Final Supplemental Environmental Impact Statement for the Nuclear Facility Portion of the Chemistry and Metallurgy Research Building Replacement Project at Los Alamos National Laboratory, Los Alamos, New Mexico

VOLUME 2
COMMENT RESPONSE DOCUMENT

AVAILABILITY OF THE
FINAL SUPPLEMENTAL ENVIRONMENTAL IMPACT STATEMENT FOR THE
NUCLEAR FACILITY PORTION OF THE CHEMISTRY AND METALLURGY
RESEARCH BUILDING REPLACEMENT PROJECT AT LOS ALAMOS NATIONAL
LABORATORY, LOS ALAMOS, NEW MEXICO (CMRR-NF SEIS)

Figure 1. Map of the Pajarito Fault System and Embudo Fault System – Southwestern Section in Northern New Mexico. **Source:** Figure 5-4 in LANL 2007 PSHA Report.

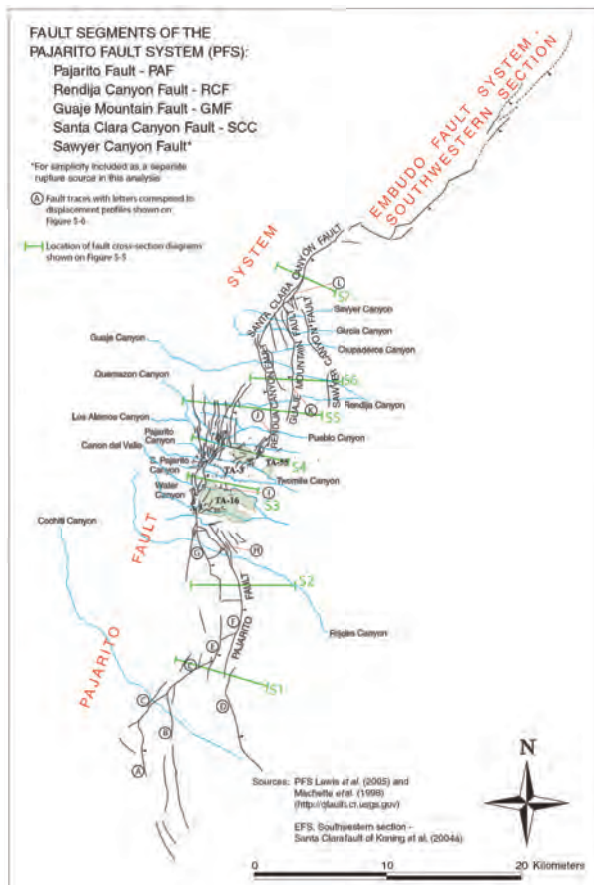
The fault locations that were used in the LANL 2007 PSHA Report and the DOE 2011 draft SEIS are displayed below on Figures 1 and 2. For comparison, the locations of the zones of intense fractures as evidence of active faults in the LANL report by Wohletz (2004) are displayed below on Figure 3.

Figure 1 above on page 7 shows the network of fault segments in the PFS where the LANL Seismic Hazards Geology Team recommends a robust kinematic model. Our review shows that the knowledge required for a robust kinematic model does not exist. Accurate knowledge is necessary of 1), the locations of the discrete faults, 2), the geometry in the subsurface of the discrete faults, and 3), the potential linkage among the discrete faults for purposes of seismic hazard analysis at the location of the proposed CMRR-NF at LANL TA-55 and at other LANL critical facilities. The location of the proposed CMRR-NF is displayed above on Figure 2.

See the response to comment 241-10 (below) with respect to location of nearest active faults.

Lewis et al. (2009) states that the southern extent and amount of displacement on the Guaje Mountain fault are not well constrained. Detailed geologic mapping of the area between the mapped southern termination of the Guaje Mountain fault and the northern side of Los Alamos Canyon has not yet been undertaken. That said, studies have completed detailed geologic mapping of LANL from Los Alamos Canyon to the north to Pajarito Canyon to the south, and from the Pajarito fault escarpment to the west to TA-46 to the east (for example, Gardner et al. 1999; Lavine et al. 2003). These studies carefully looked for the presence or absence of surface faulting associated with the Rendija Canyon and Guaje Mountain faults within LANL property. Geologic mapping at LANL to identify surface faulting is summarized by Animation 1 in Lewis et al. (2009).

Lewis et al. (2009) shows that the Rendija Canyon fault trends southward to Los Alamos Canyon, then splays southwesterly into a broad zone of deformation in LANL's TA-3. Surface faulting from the Rendija Canyon fault was not identified due south of Los Alamos Canyon, including at TA-55. The surface expression of the Guaje Mountain fault is not visible south of Pueblo Canyon, including within LANL property.

Using the data presented in Lewis et al. (2009), as a comprehensive, peer-reviewed report and map of the Pajarito fault system, the following can be stated with respect to distances from the center of the proposed CMRR-NF:

Figure 2. Mapped Faults in the Los Alamos National Laboratory Area.
Source: Figure 3-5 in the DOE 2011 SEIS for locating the proposed CMRR
Nuclear Facility at LANL TA-55.

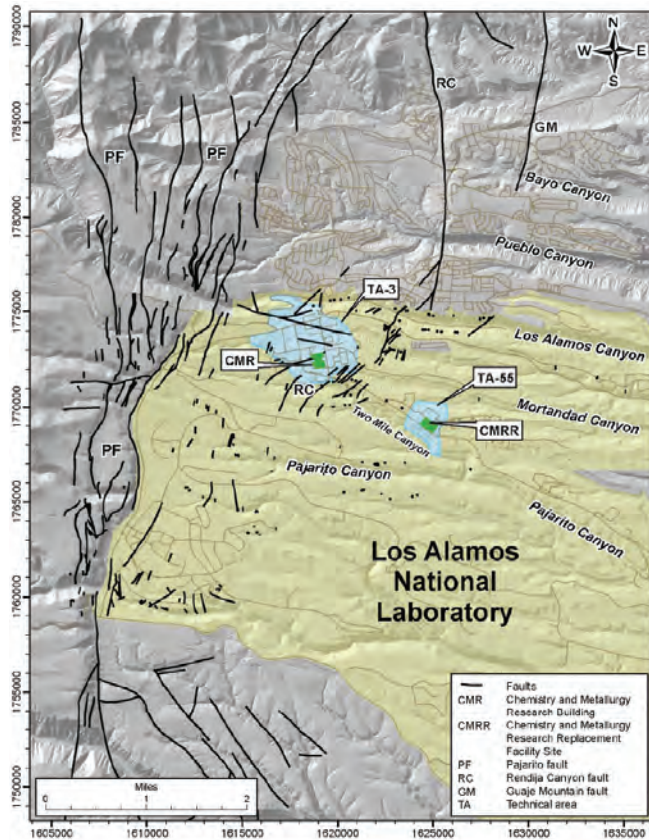
The design of the proposed CMRR-NF was based on the locations of faults shown on Figure 2. Accordingly, the distance of the proposed CMRR-NF away from faults was described in the DOE 2011 draft SEIS as follows on page 3-25:

Comment by Gilkeson and Arends. *In fact, accurate knowledge of the distance from the proposed CMRR-NF to the active Guaje Mountain Fault (GMF) does not exist according to Lewis et al., 2009 and comparison of Figures 2 and 3 shows there is disagreement among the LANL scientists on the distance from the CMRR-NF to the active Rendija Canyon Fault (RCF) and to the GMF.*

These data presented above, which are consistent with those provided in Chapter 3, Section 3.5, Geology and Soils, correspond to data used to calculate design-basis earthquake ground motions for the CMRR-NF.

It is important to note that precise locations of the strands of the Pajarito fault system, with respect to the CMRR-NF, are not needed for estimating the ground-shaking hazard at the site. The ground motion prediction models “flatten” out at short distances, less than a few kilometers for large magnitude earthquakes (magnitude > 6.5), so the hazard is not sensitive to uncertainties in faults locations of hundreds of meters. Precise fault locations are needed for assessing the hazard from surface fault rupture, but as further described below in the responses to comments 241-14 and 241-17, the potential for surface faulting at the CMRR-NF is considered very low.

Figure 3. Map in 2004 LANL Report by Wohletz showing proposed location of Rendija Canyon Fault along the western boundary of LANL TA-55 and Guaje Mountain Fault 2500 feet east of the eastern boundary of TA-55.
Source: Figure 14 in Wohletz, 2004 (LA-UR-04-8337).

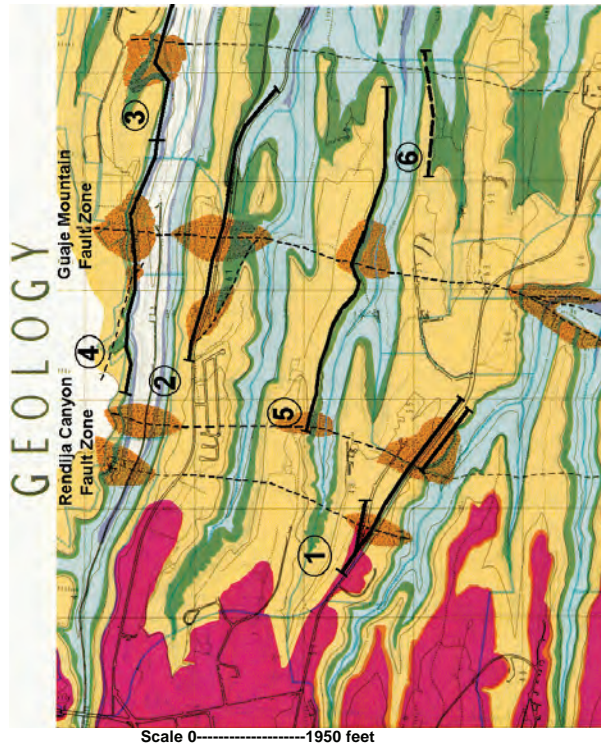
Comparison of Figures 2 and 3 shows that there is disagreement between the LANL scientists on the location of active faults close to the proposed CMRR-NF at LANL TA-55. The fault locations of Figure 2 are based on mapping of fault displacements from field investigations by LANL scientists on the Seismic Hazards Geology Team. The fault locations on Figure 3 are based on mapping of intense zones of fracturing in field investigations by LANL scientist Kenneth H. Wohletz (Wohletz, 2004). Some of the intense zones of fracturing are associated with large displacement faults. However, faults are not identified in the upper part of the Bandelier Tuff for the intense zones of fracturing on Figure 3 that are located close to the proposed CMRR-NF. The issue of the zones of intense fracturing mapped by Wohletz is Issue 1.D on page 34.

The necessary field investigations to determine the presence of active faults buried in the Bandelier Tuff at the locations of the intense fractures close to the proposed location of the CMRR-NF have not been performed. Without the field investigations, DOE is required to assume that the locations of the intense fractures on Figure 3 identify the locations of active faults and calculate the seismic hazard at the proposed CMRR-NF accordingly.

Per DOE Order 413.3, Program and Project Management for the Acquisition of Capital Assets, final or detailed design cannot be started until the NEPA document (Final SEIS in this case) has been completed, so as not to prejudice the outcome, or restrict or narrow the range of alternatives to be considered. The cost to build and operate the proposed CMRR-NF is not within the scope of the *CMRR-NF SEIS*, but it will be one aspect that NNSA takes into consideration when making its decision.

The Poisson model or process that is used in the LANL 2007 PSHA report is a state-of-practice model for the recurrence of earthquakes in a PSHA (SSHAC 1997). As described by SSHAC (1997), this model is fundamental to earthquake hazard assessment and is found to correctly model the random occurrence of earthquakes, excluding dependent events such as foreshocks and aftershocks of large earthquakes. In some instances, time-dependent models may also be incorporated in a PSHA (SSHAC 997); however, the paleoseismic data (information on ancient seismic events) for the Pajarito fault system are not adequate at this time to develop a time-dependent model for the LANL PSHA. Future additional geologic investigations may reduce slip rate uncertainty, but are not likely to impact the application of the Poisson earthquake recurrence model.

Figure 4. West to East Cross-Section D-E' on page 263 in Lewis et al., 2009.

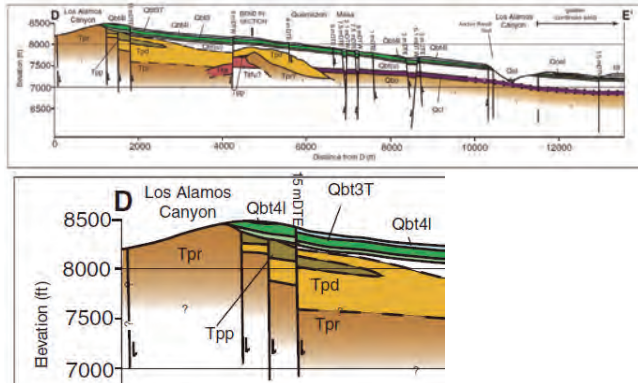
Figure 4 below is cross-section D-E' on page 263 in Lewis et al., 2009 that illustrates the large number of faults in the PFS that have propagated upward through the Bandelier Tuff. The enlarged view of the western part of cross-section D-E' shows three parallel faults where two of the faults do not propagate upward through the Bandelier Tuff. The two faults have been inactive for the past 1.25 million years.

ground surface (168 meters). The geologic formations that are most relevant to TA-55 are those that would influence seismic ground response and foundation performance. Seismic ground response, as determined by these two deep seismic characterization borings, is affected by the relatively high seismic wave velocity of the basement rocks, consisting of the Cerros del Rio basalt and Tschicoma Formation dacite (both of which are relatively hard volcanic rocks), and the much lower seismic wave velocities of the overlying, softer Bandelier Tuff. From data provided by Kleinfelder (2007a), DSC-1B was the only deep borehole to penetrate into the Tschicoma Formation dacite. In addition, the presence of the relatively soft Qbt3L between two stiffer units, Qbt3U and Qbt2, is important with respect to the seismic ground response of the site (Kleinfelder 2007a).

Figure 7-53. Comparison of the larger seismic hazard from synchronous versus simultaneous surface-eruption earthquakes at the proposed CMRR-NF at LANL TA-55
Source. Figure 7-53 in LANL 2007 PSHA Report.

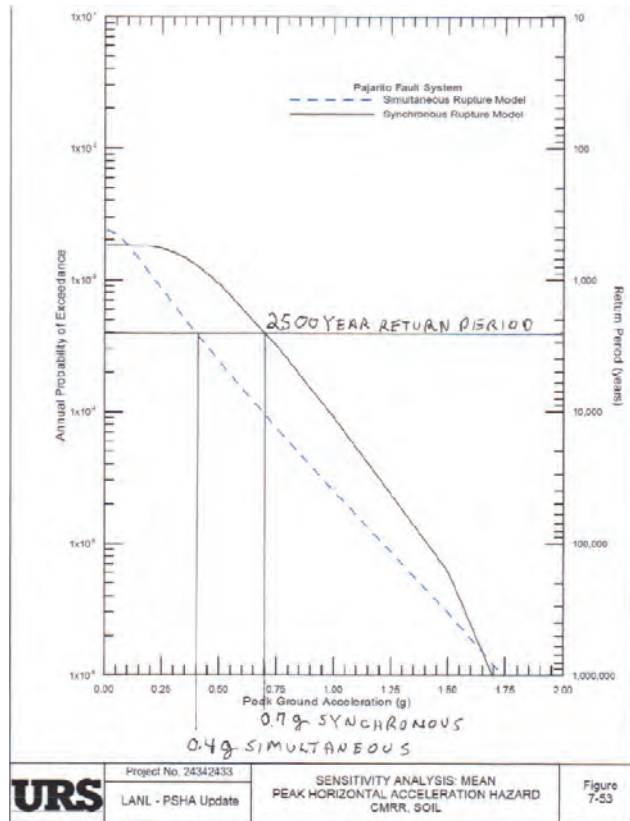
Figure 7-53 shows a much higher horizontal ground acceleration of 0.7g for synchronous ruptures of the PFS at the location of the proposed CMRR-NF compared to a lower value of 0.4g for simultaneous ruptures of the PFS.

Figure 7-53 shows that the Mean Peak Horizontal Acceleration Seismic Hazard at the proposed CMRR-NF is 75% higher for the ground-surface ruptures from multiple synchronous earthquakes in the PFS for a return period of 2,500 years at 0.7g than for the simultaneous ruptures from a single earthquake for the same return period at a lower value of 0.4g.

Figure 1. Map of the Pajarito Fault System and Embudo Fault System – Southwestern Section in Northern New Mexico. **Source:** Figure 5-4 in LANL 2007 PSHA Report.

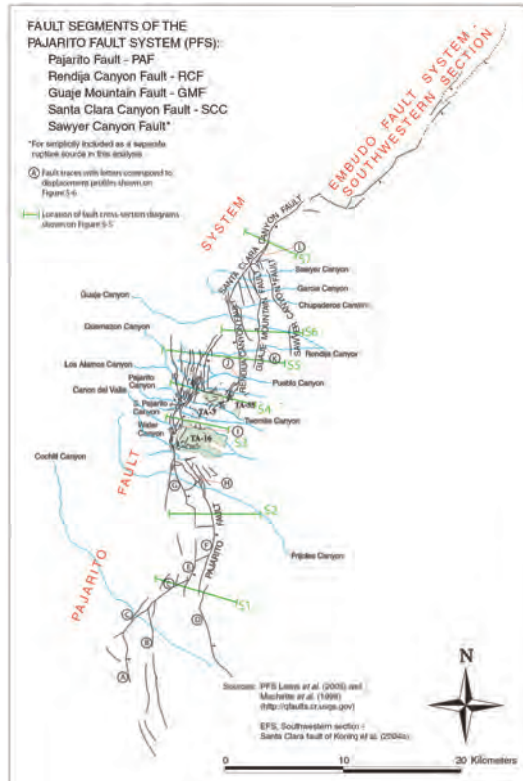
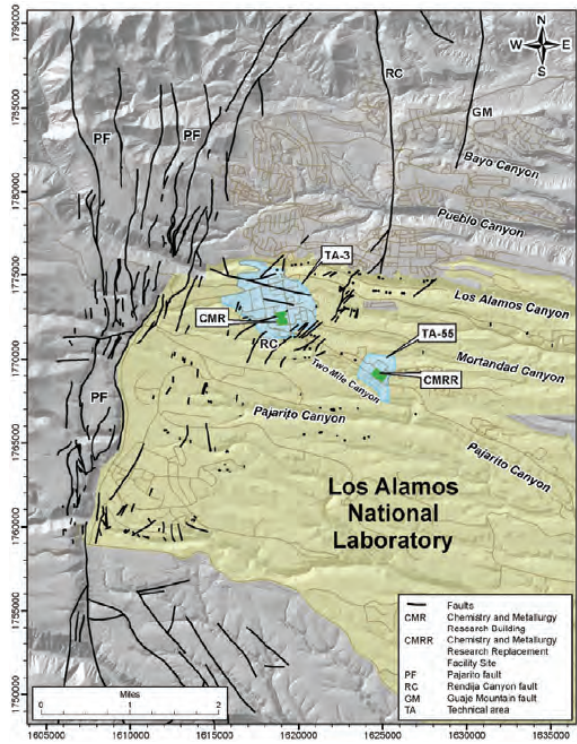
The locations of the above faults in the vicinity of LANL are shown on Figure 1. Figure 2 shows the locations of mapped faults in the LANL 2007 PSHA Report and in the DOE 2011 draft SEIS. Figure 3 is from a report by LANL scientist Kenneth H. Wohletz (Wohletz, 2004) which shows the disagreement among LANL scientists on the location of faults close to the proposed CMRR-NF. The inferred locations of faults on Figure 3 is determined from detailed field mapping of zones of intense fractures both west, north and east of the proposed CMRR-NF.

As a result of comments received on the *Draft CMRR-NF SEIS*, Chapter 3, Section 3.5, Geology and Soils, of the *CMRR-NF SEIS* was revised to improve the description of faulting and seismic hazards at LANL.

The fault shown 800 feet (244 meters) west of the proposed CMRR-NF, by Vaniman and Wohletz (1990) and Wohletz (2004), is an inferred fault, meaning that the fault is interpreted to be present at some depth below the location at which it is mapped; however, no evidence for surface-rupturing faults was found along that mapped trace. The work of Vaniman and Wohletz helped spur the LANL Seismic Hazards Program to conduct detailed, site-specific studies around TA-55 (for example, Gardner et al. 1998, 1999, 2008) to determine the presence or absence of surface-rupturing faults, using detailed investigative methods. These methods included conventional geologic mapping at 1:1,200 scale, high-precision total station geologic mapping of Bandelier Tuff subunit contacts to identify faults, and large-scale trenching investigations at the site of the proposed CMRR-NF. Gardner et al. (1998, 1999) identified no faults or offsets along geologic contacts suggesting the presence of a fault at TA-55. Although Gardner et al. (2008) did observe some fractures and small faults confined within units of the tuff, they concluded that fractures and faults exposed at the proposed CMRR site formed very shortly after emplacement of the tuff, 1.26 million years ago, as a result of cooling and compaction, and the structures identified at the proposed CMRR-NF site pose no independent seismic surface rupture hazard. No evidence for active faulting was identified by Gardner et al. (1998, 1999, 2008) near the proposed CMRR-NF, as inferred by early studies of Vaniman and Wohletz (1990) and Wohletz (2004).

Figure 2. Mapped Faults in the Los Alamos National Laboratory Area.
Source: Figure 3-5 in the DOE 2011 SEIS for locating the proposed CMRR Nuclear Facility at LANL TA-55.

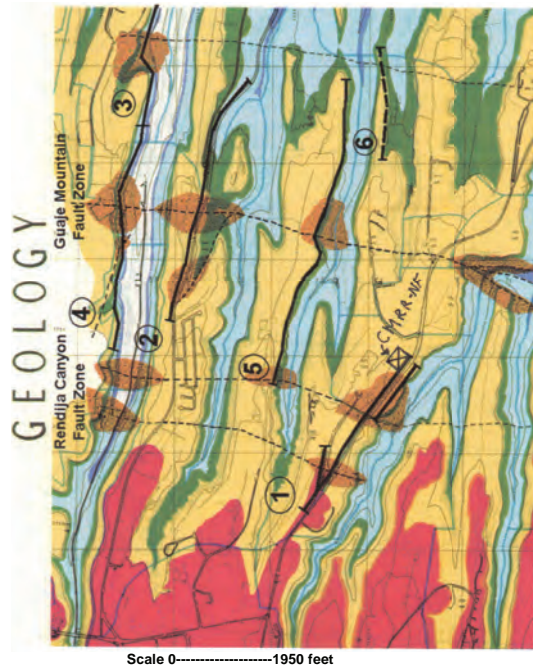
The LANL 2007 PSHA Report and the DOE 2011 draft SEIS did not use the demonstrated zones of intense fractures on Figure 3 to identify potential locations for buried active faults. The fault map in the LANL 2007 PSHA Report (see Figure 2) was limited to where field studies mapped displacements on faults. However, the NRC 1997 SH Guidance Report in Section 4 on page 54 describes the importance for knowledge of buried active faults close to the proposed CMRR-NF and for other critical LANL facilities in the following four issue areas:

nearest laterally continuous, surface-rupturing fault to the proposed CMRR-NF is located approximately 3,300 feet (1,000 meters) to the west-northwest, in the western portion of TA-64, with 3 feet (1 meter) of down-to-the-west displacement.
